HISTORIC AND DESIGN REVIEW COMMISSION

HDRC CASE NO: 2024-298
ADDRESS: 516 E MULBERRY AVE
LEGAL DESCRIPTION: NCB 3090 BLK 6 LOT 9
ZONING: R-4 CD, H
CITY COUNCIL DIST.: 1
DISTRICT: Monte Vista Historic District
APPLICANT: Jose Calzada/Architectura SA, Inc
OWNER: Rafael Saavedra Sada/MULBERRY PROJECT LLC
TYPE OF WORK: New construction of two (2) 1-story, single-family structures
APPLICATION RECEIVED: August 16, 2024
60-DAY REVIEW: October 15, 2024
CASE MANAGER: Rachel Rettaliata

The applicant is requesting a Certificate of Appropriateness for approval to construct two (2) 1-story, single-family structures at 516 E Mulberry.

2 LANDSCAPE PLAN
3/32" = 1'-0"

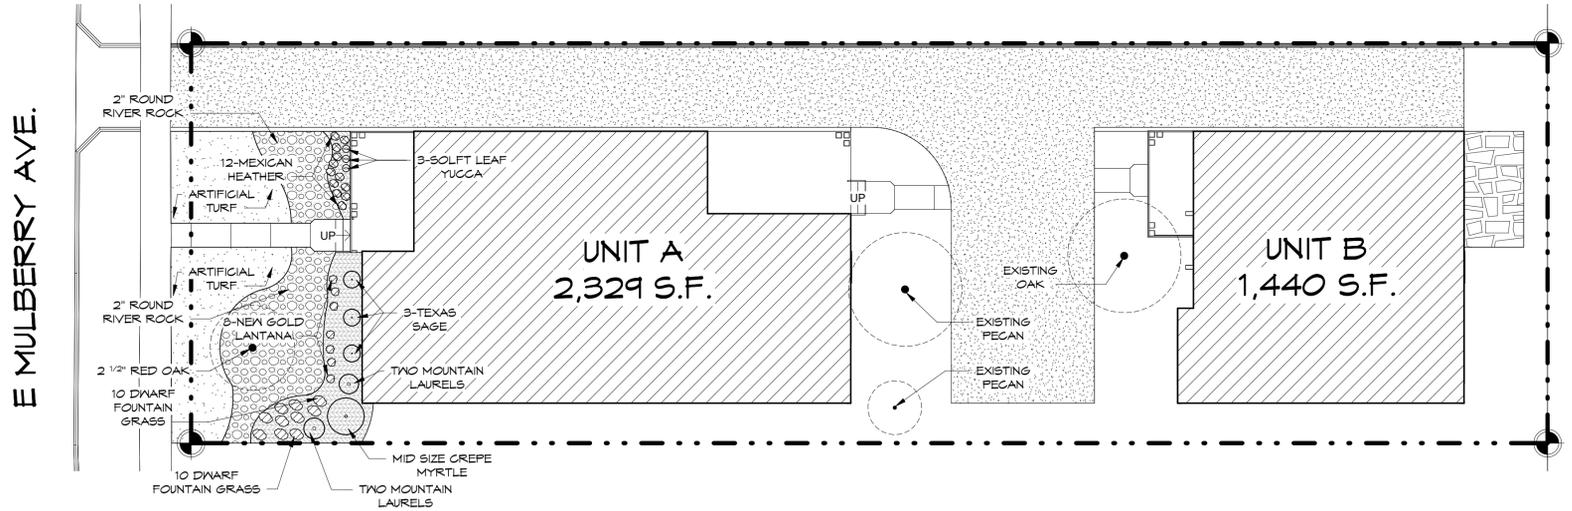
- s. LANDSCAPING PLAN – Per the Historic Design Guidelines, landscaping should feature at least 50 percent of native plantings and greenspace. The applicant has submitted a landscaping plan featuring native plantings, river rock that is less than 2 inches in diameter, and artificial turf. Staff finds that the applicant should install additional plantings or grass in lieu of the proposed artificial turf.

- x. The applicant submits a final landscaping plan to staff for review based on finding t.

- x. The applicant submits a final landscaping plan to staff for review based on finding t. ***This stipulation has been met.***
- c. DESIGN REVIEW COMMITTEE – The applicant attended a Design Review Committee on May 24, 2022. The discussion focused on massing, noting the heights of neighboring structures on a future submission, materiality, fenestration, driveway configuration, and site work.

1 EXTERIOR ELEVATION UNIT A
1/4" = 1'-0"

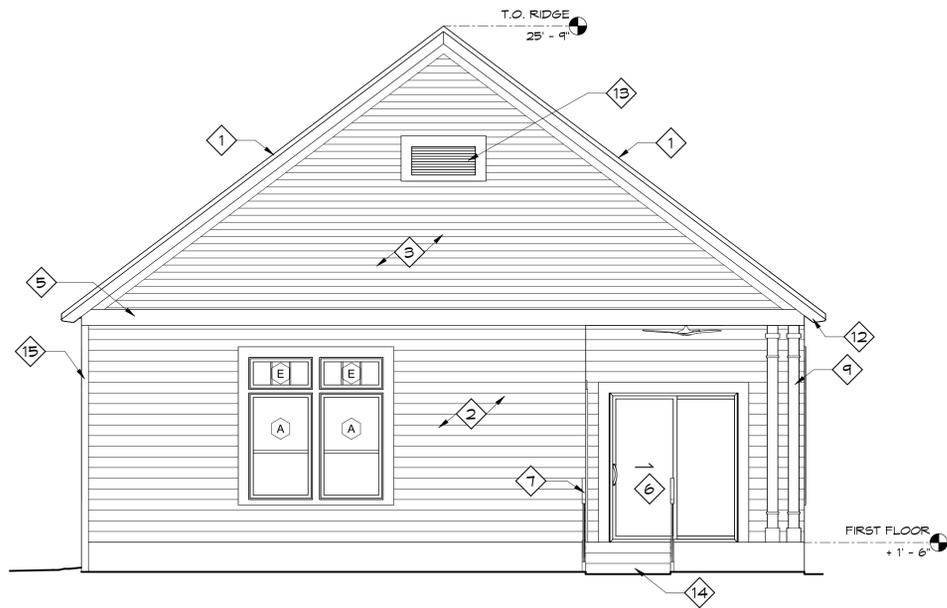
- vi. That the applicant modifies the windows on the west elevation of Unit A to feature traditional proportions based on finding m. ***This stipulation has been met.***

1 EXTERIOR ELEVATION UNIT B
1/4" = 1'-0"

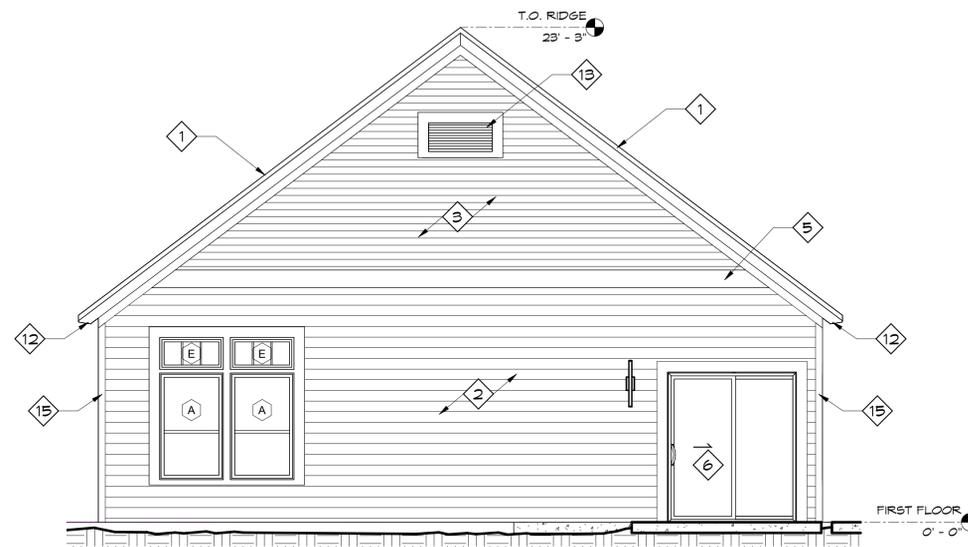
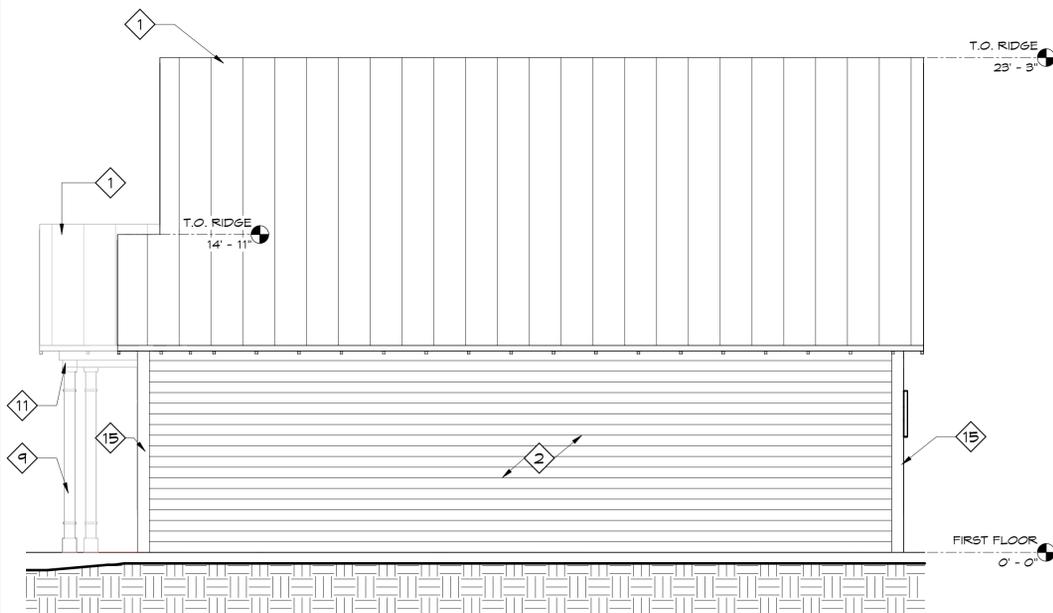
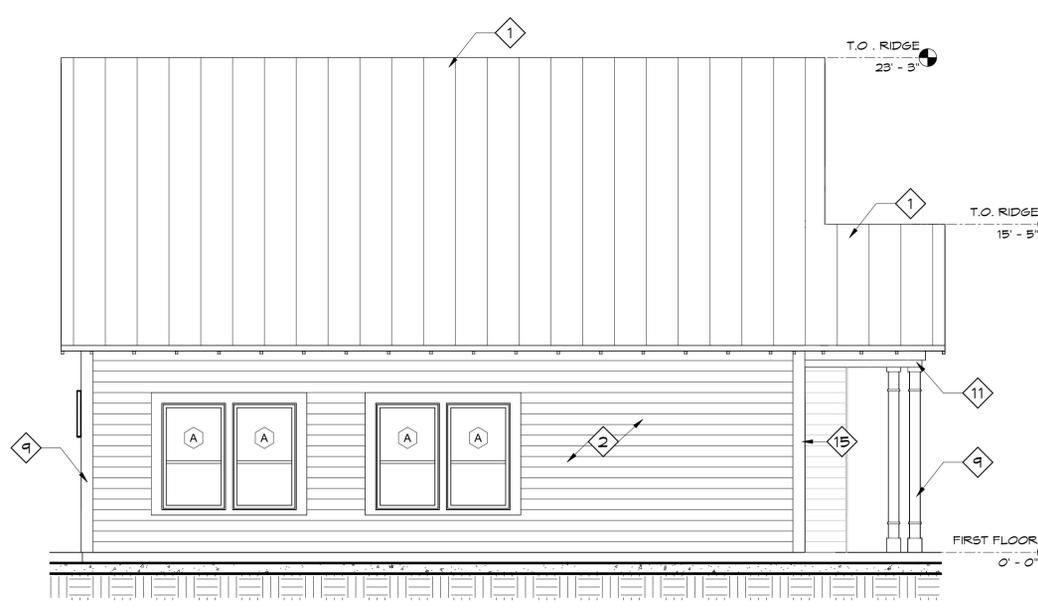
- v. That the applicant proposes fenestration on the west elevation of Unit B based on finding n.
- vi. That the applicant installs additional plantings or grass in lieu of the proposed artificial turf based on finding s. An updated landscaping plan must be submitted to staff for review and approval prior to the issuance of a Certificate of Appropriateness.

- vi. That the applicant modifies the windows on the west elevation of Unit A to feature traditional proportions based on finding m.
- vii. That the applicant proposes fenestration on the west elevation of Unit B based on finding n.

7. Conceptual Site Plan

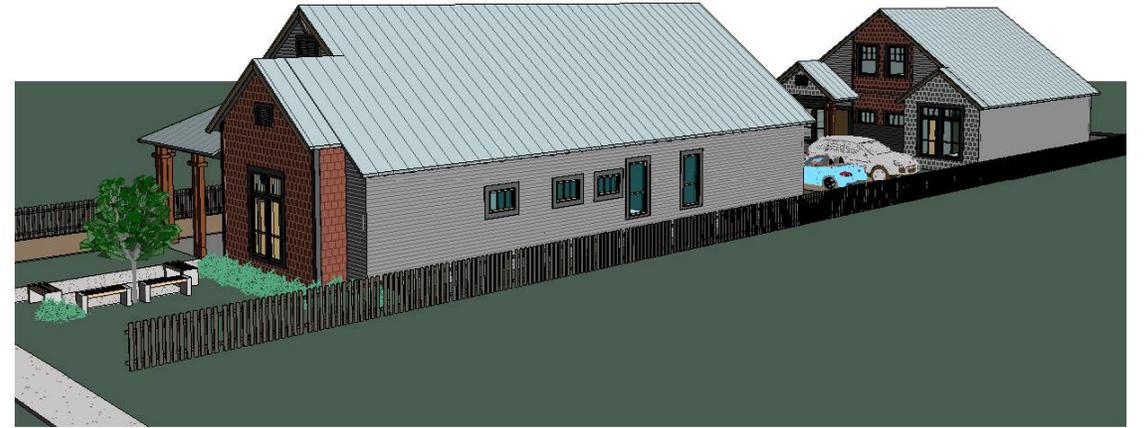
Jeffrey Fetzter: The site plan seems appropriate, where the large house is on the street front and an accessory building in the back. I would revisit the height of the rear building and the accessory building has larger windows on the second floor, which makes it look more prominent. What is the width of the driveway?

JF: Do you have a site plan showing the adjacent property setbacks? I would recommend including the dimensions of the surrounding setbacks.
